ACCESSIBILITY ASSESSMENT

ADA TITLE II ASSESSMENT

Abernethy Hall
131 South Columbia Street
Chapel Hill, North Carolina 27514

July 22, 2024

Map for Barrier ID: AX455995

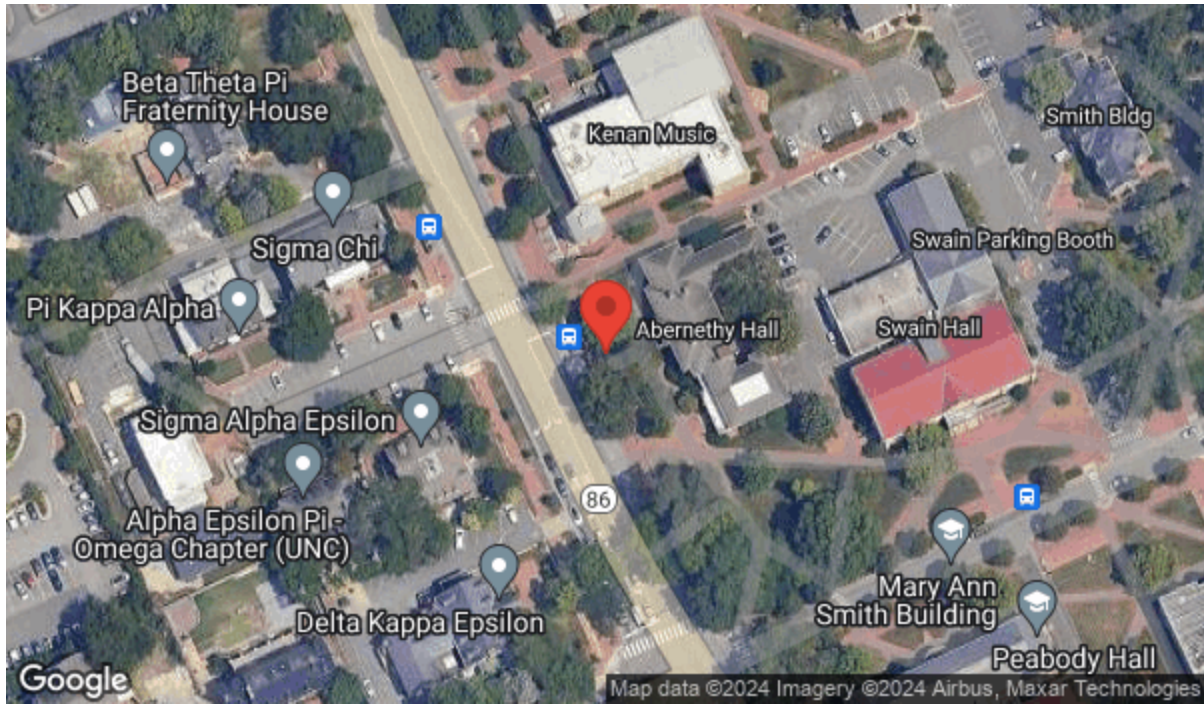
Assembly	Exterior Access Route
Type	Stairs
ADA Standard	505
Barrier Detail	Handrails are not compliant or are not provided.
Location Description	Columbia Street
Observed	May 20, 2024 by Brian.rogers@bureauveritas.com
Site Conditions	Handrails are not provided on the stairs.

Install handrails on both sides of all stairs that comply with guidelines. Handrails shall be provided on both sides of stairs. Handrails shall be continuous within the full length of each stair flight or ramp run. Inside handrails on switchback or dogleg stairs and ramps shall be continuous between flights or runs. Top of gripping surfaces of handrails shall be 34" minimum and 38" maximum vertically above walking surfaces, stair nosings, and ramp surfaces. Handrails shall be at a consistent height above walking surfaces, stair nosings, and ramp surfaces. Clearance between handrail gripping surfaces and adjacent surfaces shall be 1-1/2" minimum. Handrail gripping surfaces shall be continuous along their length and shall not be obstructed along their tops or sides. The bottoms of handrail gripping surfaces shall not be obstructed for more than 20% of their length. Where provided, horizontal projections shall occur 1-1/2" minimum below the bottom of the handrail gripping surface. [EXCEPTIONS: 1. Where handrails are provided along walking surfaces with slopes not steeper than 1:20, the bottoms of handrail gripping surfaces shall be permitted to be obstructed along their entire length where they are integral to crash rails or bumper guards. 2. The distance between horizontal projections and the bottom of the gripping surface shall be permitted to be reduced by 1/8" for each 1/2" of additional handrail perimeter dimension that exceeds 4".] Handrail gripping surfaces with a circular cross section shall have an outside diameter of 1-1/4" minimum and 2" maximum. Handrail gripping surfaces with a non-circular cross section shall have a perimeter dimension of 4" minimum and 6-1/4" maximum, and a cross-section dimension of 2-1/4" maximum. Handrail gripping surfaces and any surfaces adjacent to them shall be free of sharp or abrasive elements and shall have rounded edges. Handrails shall not rotate within their fittings. Handrail gripping surfaces shall extend beyond and in the same direction of stair flights. At the top of a stair flight, handrails shall extend horizontally above the landing for 12" minimum beginning directly above the first riser nosing. At the bottom of a stair flight, handrails shall extend at the slope of the stair flight for a horizontal distance at least equal to one tread depth beyond the last riser nosing. Extensions shall return to a wall, guard, or the landing surface, or shall be continuous to the handrail of an adjacent stair flight. [EXCEPTIONS: 1. Extensions shall not be required for continuous handrails at the inside turn of switchback or dogleg stairs and ramps AND 3. In alterations, full extensions of handrails shall not be required where such extensions would be hazardous due to plan configuration.] [ADVISORY: It is advisable, but not required, to provide a handrail at a height designed for children. When children are the principal users in a building or facility (e.g., elementary schools), a second set of handrails at an appropriate height can assist them and aid in preventing accidents. A maximum height of 28" measured to the top of the gripping surface from the ramp surface or stair nosing is recommended for handrails designed for children. Sufficient vertical clearance between upper and lower handrails, 9" minimum, should be provided to help prevent entrapment.]

Map for Barrier ID: AX455998

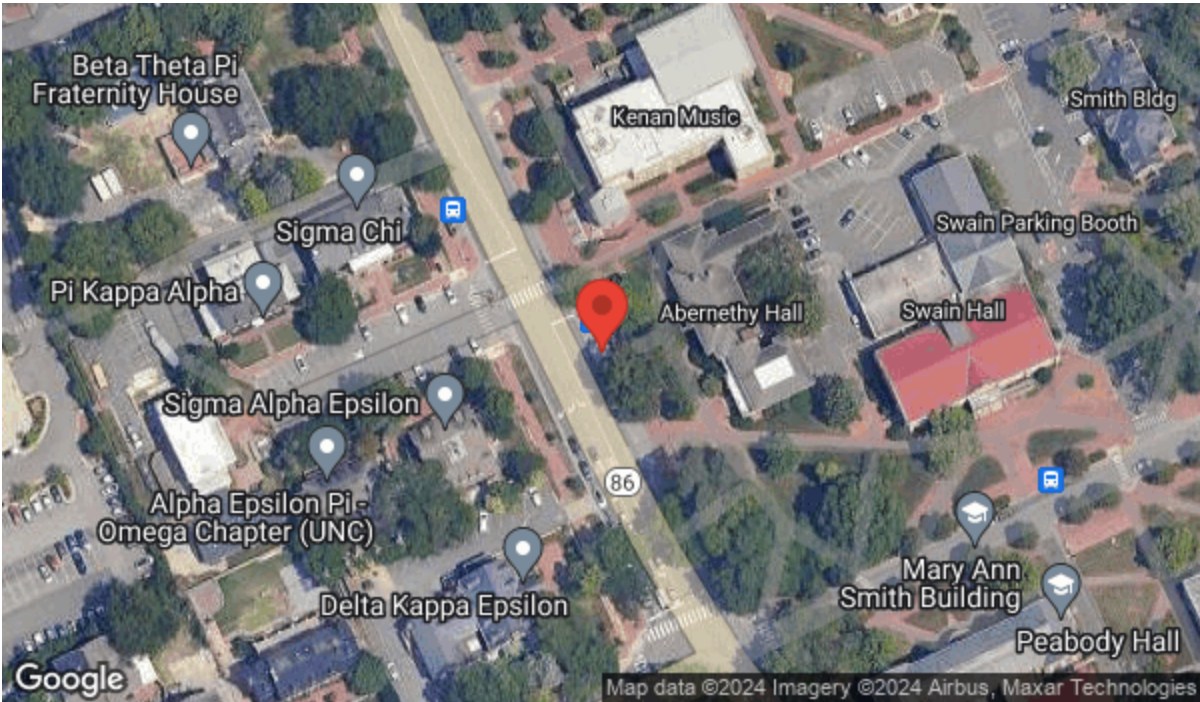
Assembly	Exterior Access Route	
Type	Stairs	
ADA Standard	2009 ANSI A117.1-504.5	
Barrier Detail		
NORTH CAROLINA: The stair tread, at the leading 2" at the stair nosing, does not have a visual contrast of dark-on-light or light-on-dark distinguished from the remainder of the tread.		
Location Description	Columbia Street	
Observed	May 20, 2024 by Brian.rogers@bureauveritas.com	
Site Conditions	The stair treads do not have visual contrast.	
Resolution		
Install a visual contrast on each stair tread at the nosing. At stair nosings, the leading 2" of tread shall have visual contrast of dark-on-light or light-on-dark from the remainder of the tread.		
Quantity	Unit Cost	Total Cost
5 Riser	125.00	\$ 625
Priority	1

Map for Barrier ID: AX455996

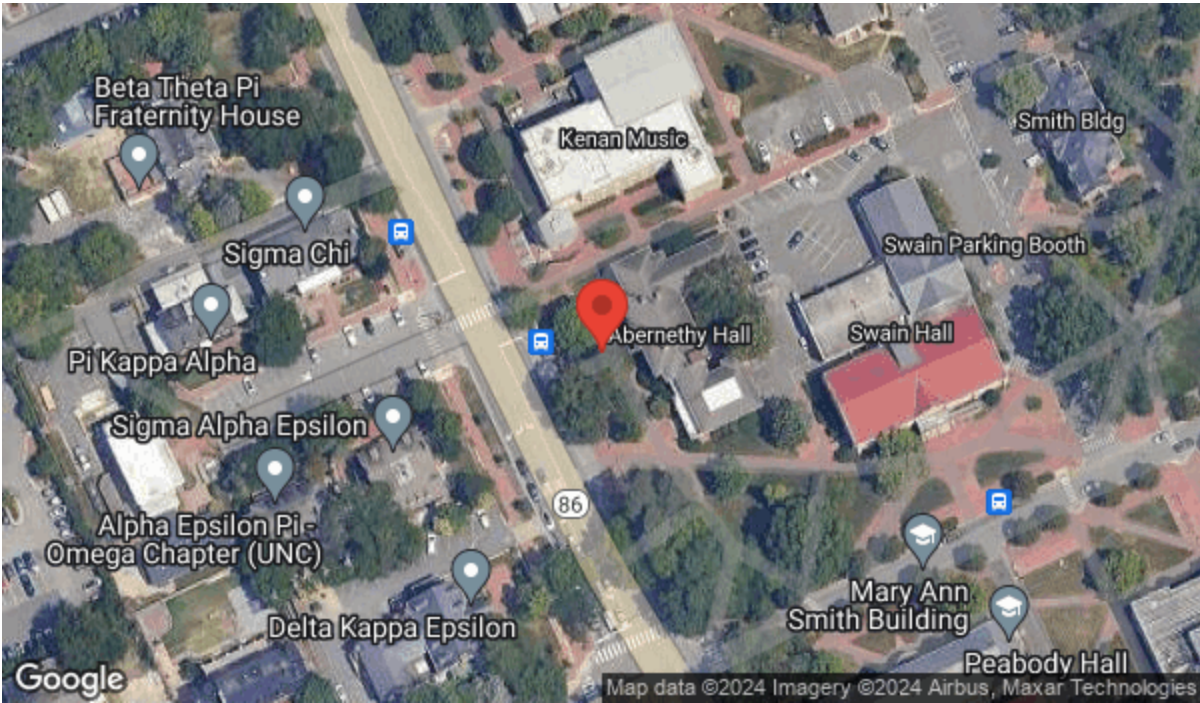
Assembly	Exterior Access Route
Type	Stairs
ADA Standard	505
Barrier Detail	Handrails are not compliant or are not provided.
Location Description	Columbia Street Main Entrance
Observed	May 20, 2024 by Brian.rogers@bureauveritas.com

Install handrails on both sides of all stairs that comply with guidelines. Handrails shall be provided on both sides of stairs. Handrails shall be continuous within the full length of each stair flight or ramp run. Inside handrails on switchback or dogleg stairs and ramps shall be continuous between flights or runs. Top of gripping surfaces of handrails shall be 34" minimum and 38" maximum vertically above walking surfaces, stair nosings, and ramp surfaces. Handrails shall be at a consistent height above walking surfaces, stair nosings, and ramp surfaces. Clearance between handrail gripping surfaces and adjacent surfaces shall be 1-1/2" minimum. Handrail gripping surfaces shall be continuous along their length and shall not be obstructed along their tops or sides. The bottoms of handrail gripping surfaces shall not be obstructed for more than 20% of their length. Where provided, horizontal projections shall occur 1-1/2" minimum below the bottom of the handrail gripping surface. [EXCEPTIONS: 1. Where handrails are provided along walking surfaces with slopes not steeper than 1:20, the bottoms of handrail gripping surfaces shall be permitted to be obstructed along their entire length where they are integral to crash rails or bumper guards. 2. The distance between horizontal projections and the bottom of the gripping surface shall be permitted to be reduced by 1/8" for each 1/2" of additional handrail perimeter dimension that exceeds 4".] Handrail gripping surfaces with a circular cross section shall have an outside diameter of 1-1/4" minimum and 2" maximum. Handrail gripping surfaces with a non-circular cross section shall have a perimeter dimension of 4" minimum and 6-1/4" maximum, and a cross-section dimension of 2-1/4" maximum. Handrail gripping surfaces and any surfaces adjacent to them shall be free of sharp or abrasive elements and shall have rounded edges. Handrails shall not rotate within their fittings. Handrail gripping surfaces shall extend beyond and in the same direction of stair flights. At the top of a stair flight, handrails shall extend horizontally above the landing for 12" minimum beginning directly above the first riser nosing. At the bottom of a stair flight, handrails shall extend at the slope of the stair flight for a horizontal distance at least equal to one tread depth beyond the last riser nosing. Extensions shall return to a wall, guard, or the landing surface, or shall be continuous to the handrail of an adjacent stair flight. [EXCEPTIONS: 1. Extensions shall not be required for continuous handrails at the inside turn of switchback or dogleg stairs and ramps AND 3. In alterations, full extensions of handrails shall not be required where such extensions would be hazardous due to plan configuration.] [ADVISORY: It is advisable, but not required, to provide a handrail at a height designed for children. When children are the principal users in a building or facility (e.g., elementary schools), a second set of handrails at an appropriate height can assist them and aid in preventing accidents. A maximum height of 28" measured to the top of the gripping surface from the ramp surface or stair nosing is recommended for handrails designed for children. Sufficient vertical clearance between upper and lower handrails, 9" minimum, should be provided to help prevent entrapment.]

Map for Barrier ID: AX455997

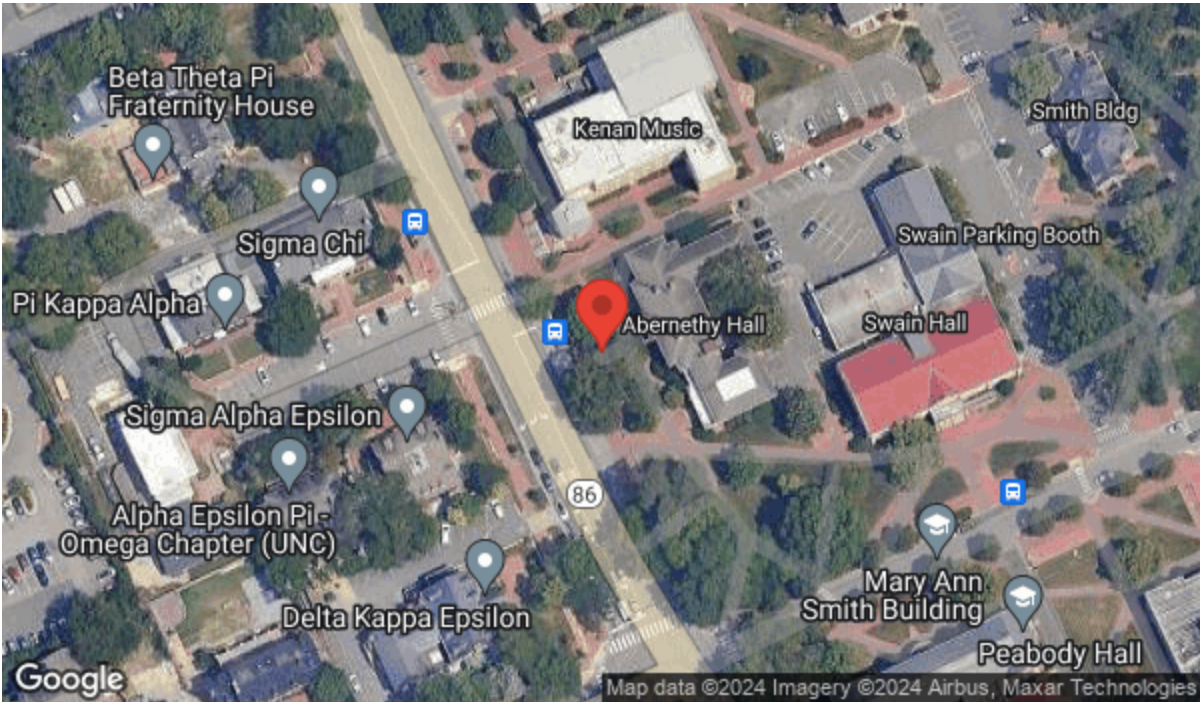
Assembly	Exterior Access Route	
Type	Stairs	
ADA Standard	2009 ANSI A117.1-504.5	
Barrier Detail		
NORTH CAROLINA: The stair tread, at the leading 2" at the stair nosing, does not have a visual contrast of dark-on-light or light-on-dark distinguished from the remainder of the tread.		
Location Description	Columbia Street Main Entrance	
Observed	May 20, 2024 by Brian.rogers@bureauveritas.com	
Site Conditions	The stair treads do not have visual contrast.	
Resolution		
Install a visual contrast on each stair tread at the nosing. At stair nosings, the leading 2" of tread shall have visual contrast of dark-on-light or light-on-dark from the remainder of the tread.		
Quantity	Unit Cost	Total Cost
6 Riser	125.00	\$ 750
Priority	1

Map for Barrier ID: AX456000

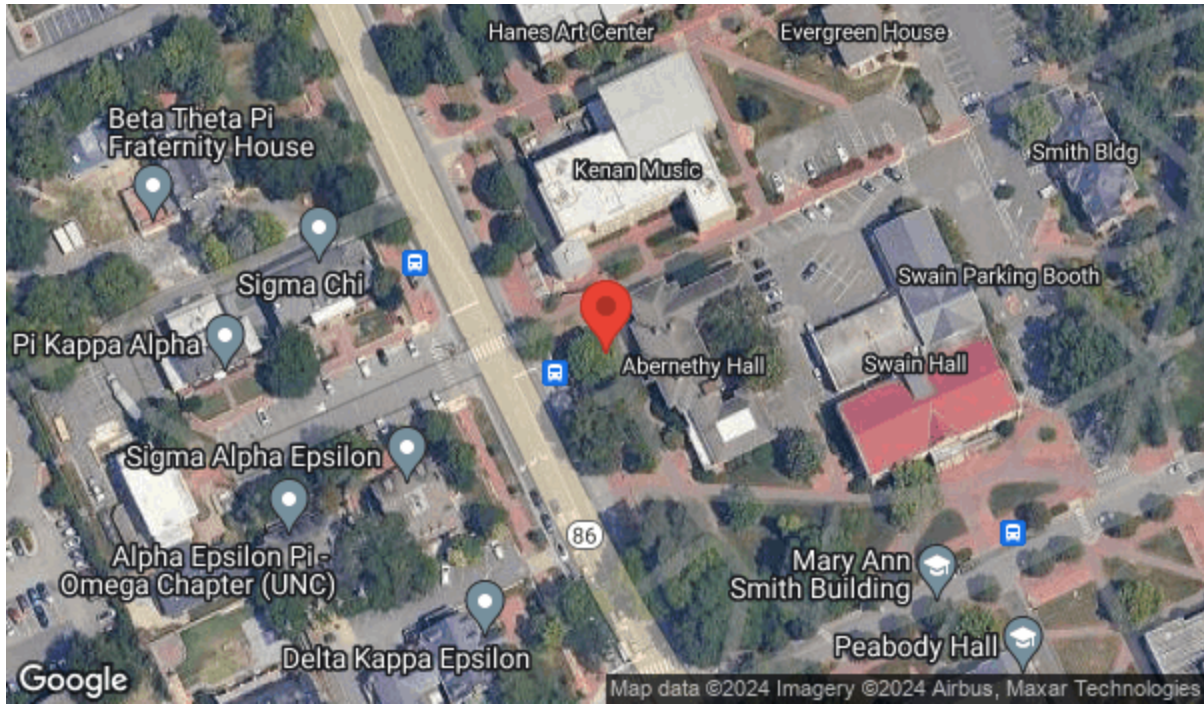
Assembly	Exterior Access Route	
Type	Protruding Object	
ADA Standard	403.5.1; 403.5.3	
Barrier Detail		
Sidewalk does not meet the 36" minimum clear width requirement (60" minimum where passing areas are present).		
Location Description	Exterior Brick Walk	
Observed	May 20, 2024 by Brian.rogers@bureauveritas.com	
Site Conditions	Vegetation reduces the brick walkway to 16" to 24" in 2 spots each 10' wide	
Resolution		
Remove vegetation that is encroaching into the required clear width. The sidewalk should be removed and replaced with a compliant sidewalk. The clear width of walking surfaces shall be 36" minimum. [EXCEPTION: The clear width shall be permitted to be reduced to 32" minimum for a length of 24" maximum provided that reduced width segments are separated by segments that are 48" long minimum and 36" wide minimum.] An accessible route has maximum 1:20 (5%) running slope and maximum 1:50 (2%) cross slope. [EXCEPTION: Cross slopes not greater than 1:48 (2.08%) are permitted.]

Map for Barrier ID: AX456032

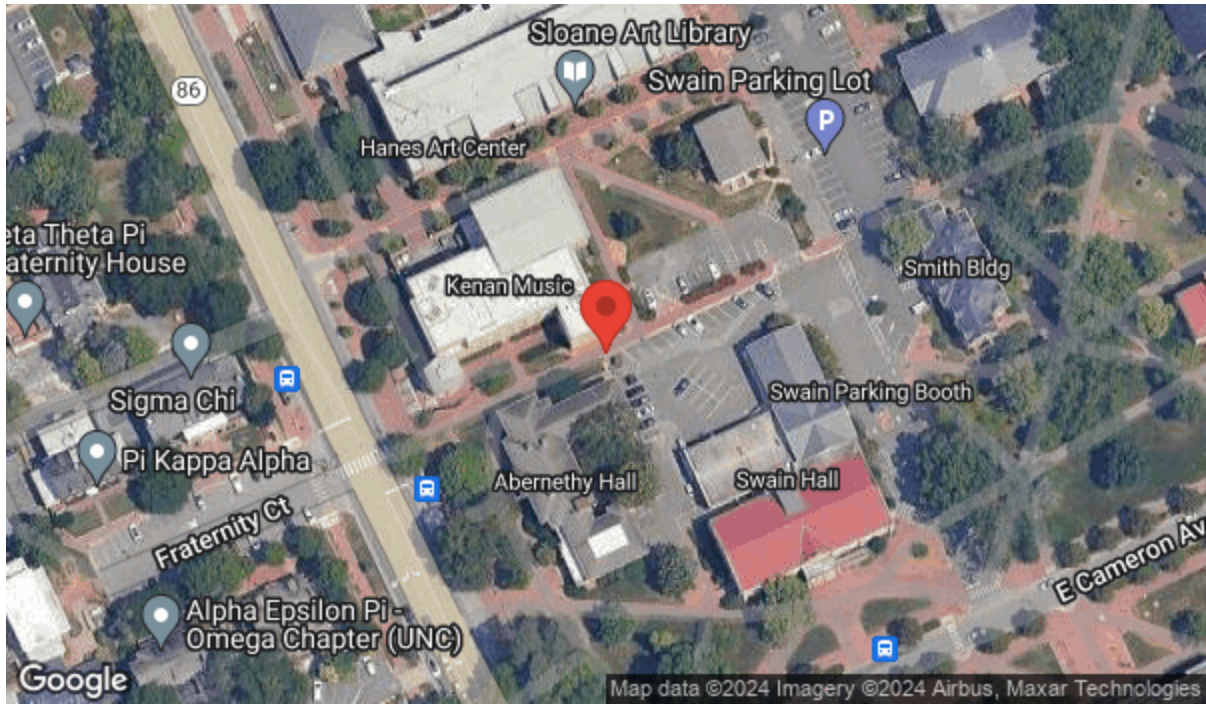
Assembly	Exterior Access Route
Type	Stairs
ADA Standard	505
Barrier Detail	Handrails are not compliant or are not provided.
Location Description	Side Exit
Observed	May 20, 2024 by Brian.rogers@bureauveritas.com
Site Conditions	Handrails are not provided on the stairs.

Install handrails on both sides of all stairs that comply with guidelines. Handrails shall be provided on both sides of stairs. Handrails shall be continuous within the full length of each stair flight or ramp run. Inside handrails on switchback or dogleg stairs and ramps shall be continuous between flights or runs. Top of gripping surfaces of handrails shall be 34" minimum and 38" maximum vertically above walking surfaces, stair nosings, and ramp surfaces. Handrails shall be at a consistent height above walking surfaces, stair nosings, and ramp surfaces. Clearance between handrail gripping surfaces and adjacent surfaces shall be 1-1/2" minimum. Handrail gripping surfaces shall be continuous along their length and shall not be obstructed along their tops or sides. The bottoms of handrail gripping surfaces shall not be obstructed for more than 20% of their length. Where provided, horizontal projections shall occur 1-1/2" minimum below the bottom of the handrail gripping surface. [EXCEPTIONS: 1. Where handrails are provided along walking surfaces with slopes not steeper than 1:20, the bottoms of handrail gripping surfaces shall be permitted to be obstructed along their entire length where they are integral to crash rails or bumper guards. 2. The distance between horizontal projections and the bottom of the gripping surface shall be permitted to be reduced by 1/8" for each 1/2" of additional handrail perimeter dimension that exceeds 4".] Handrail gripping surfaces with a circular cross section shall have an outside diameter of 1-1/4" minimum and 2" maximum. Handrail gripping surfaces with a non-circular cross section shall have a perimeter dimension of 4" minimum and 6-1/4" maximum, and a cross-section dimension of 2-1/4" maximum. Handrail gripping surfaces and any surfaces adjacent to them shall be free of sharp or abrasive elements and shall have rounded edges. Handrails shall not rotate within their fittings. Handrail gripping surfaces shall extend beyond and in the same direction of stair flights. At the top of a stair flight, handrails shall extend horizontally above the landing for 12" minimum beginning directly above the first riser nosing. At the bottom of a stair flight, handrails shall extend at the slope of the stair flight for a horizontal distance at least equal to one tread depth beyond the last riser nosing. Extensions shall return to a wall, guard, or the landing surface, or shall be continuous to the handrail of an adjacent stair flight. [EXCEPTIONS: 1. Extensions shall not be required for continuous handrails at the inside turn of switchback or dogleg stairs and ramps AND 3. In alterations, full extensions of handrails shall not be required where such extensions would be hazardous due to plan configuration.] [ADVISORY: It is advisable, but not required, to provide a handrail at a height designed for children. When children are the principal users in a building or facility (e.g., elementary schools), a second set of handrails at an appropriate height can assist them and aid in preventing accidents. A maximum height of 28" measured to the top of the gripping surface from the ramp surface or stair nosing is recommended for handrails designed for children. Sufficient vertical clearance between upper and lower handrails, 9" minimum, should be provided to help prevent entrapment.]

Photos for Barrier ID: AX456034

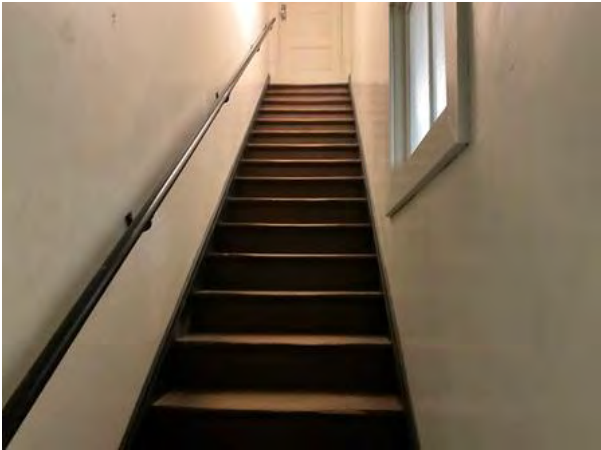
Assembly	Interior Access Route
Type	Stairs
ADA Standard	2009 ANSI A117.1-504.5
Barrier Detail	
NORTH CAROLINA: The stair tread, at the leading 2" at the stair nosing, does not have a visual contrast of dark-on-light or light-on-dark distinguished from the remainder of the tread.	
Location Description	Stair 100B
Observed	May 20, 2024 by Brian.rogers@bureauveritas.com
Site Conditions	Treads do not have contrast at the nose of the step.

Install a visual contrast on each stair tread at the nosing. At stair nosings, the leading 2" of tread shall have visual contrast of dark-on-light or light-on-dark from the remainder of the tread.

Photos for Barrier ID: AX456066

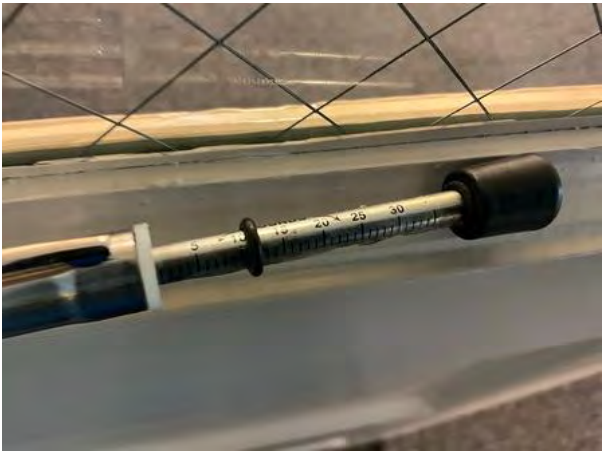
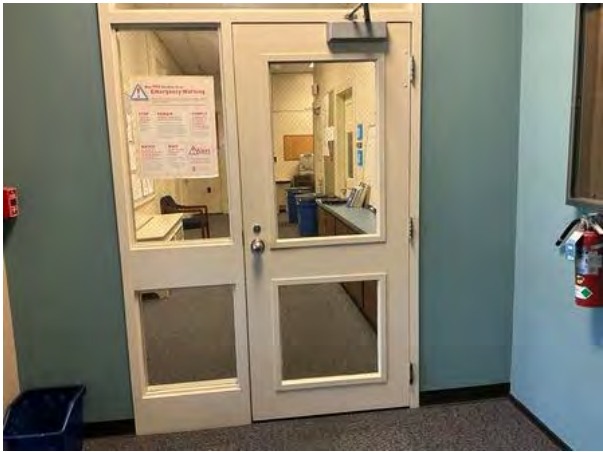
Assembly	Interior Access Route	
Type	Door	
ADA Standard	404.2.9	
Barrier Detail		
The opening force required to open the accessible, hinged, non-fire door is more than 5 pounds.		
Location Description	Top Staircase Doors	
Observed	May 20, 2024 by Brian.rogers@bureauveritas.com	
Site Conditions	All three doors require 10 pounds of pressure to open	
Resolution		
Adjust the closer or replace with a door that requires no more than 5 pounds of force for pushing or pulling the door open. The force at the latch, the force to set the door in motion, and the force to fully open the door shall be maximum 5 pounds. These forces do not apply to the force required to retract latch bolts or disengage other devices that hold the door or gate in a closed position.		
Quantity	Unit Cost	Total Cost
3 EA	458.00	\$ 1,374
Priority	1
